Subject: Broken Hill Battery energy Storage System – Environmental Impact Assessment

Thank you for your request dated 28 May 2021 seeking advice from the Biodiversity and Conservation Division (BCD) of the Department of Planning, Industry and Environment (the Department) about the Environmental Impact Statement (EIS) for the Broken Hill Battery Energy Storage System (BESS).

ATTACHMENT A – BCD Assessment Summary for Broken Hill BESS Environmental Impact Statement (SSD 11437498)
ATTACHMENT B – Detailed comments for Broken Hill BESS Environmental Impact Statement (SSD 11437498)

Figure A.1 Aerial imagery dated 2013 (DPIE) showing native vegetation patterns on the subject land. Area within the blue boundary does not appear to match Plot 3 location.

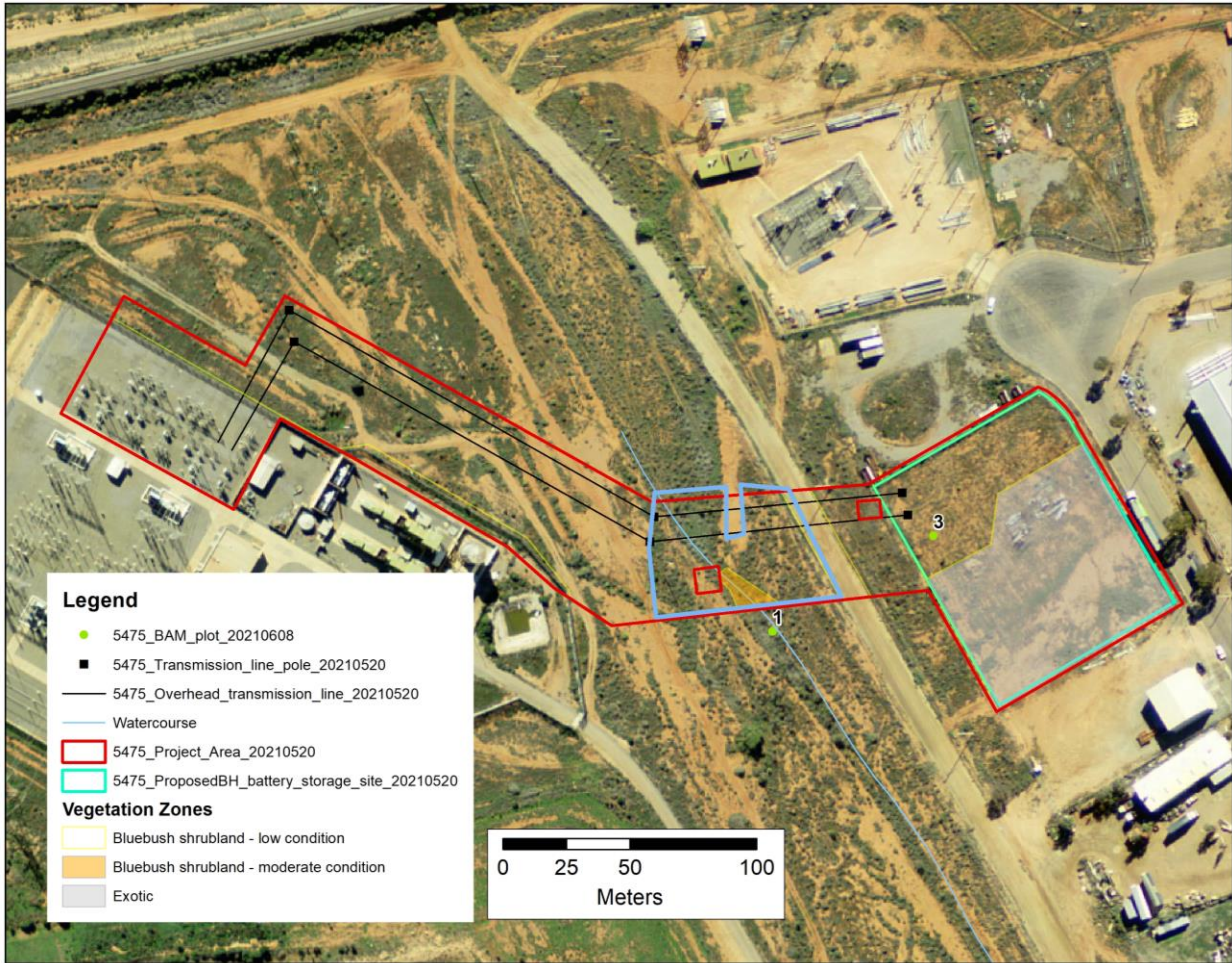
More evidence is needed to justify use of BAM Plot 3 to represent the assessed vegetation zone #1 (PCT 155 low condition).

The area around BAM Plot 3 does not appear to be representative of the vegetation to be impacted by the transmission connection on the adjacent Crown land (Lot 7302, DP 1181129).

The Broken Hill aerial imagery available to BCD was captured in 2013 (figure A.1). Aerial imagery from 2021 available on Google Maps has also been reviewed (figure A.2) and shows the difference in vegetation pattern between Lots 57 and 58 and the Crown land traversed by the proposed transmission line (particularly within the blue line).

- 2.4. *BAM plot numbers to be included on Figure 3 (matching plot numbers in Annex 2 and spatial data)*
- 2.5. *Provide more evidence to justify use of BAM Plot 3 to represent the assessed vegetation zone #1 (PCT 155 low condition)*
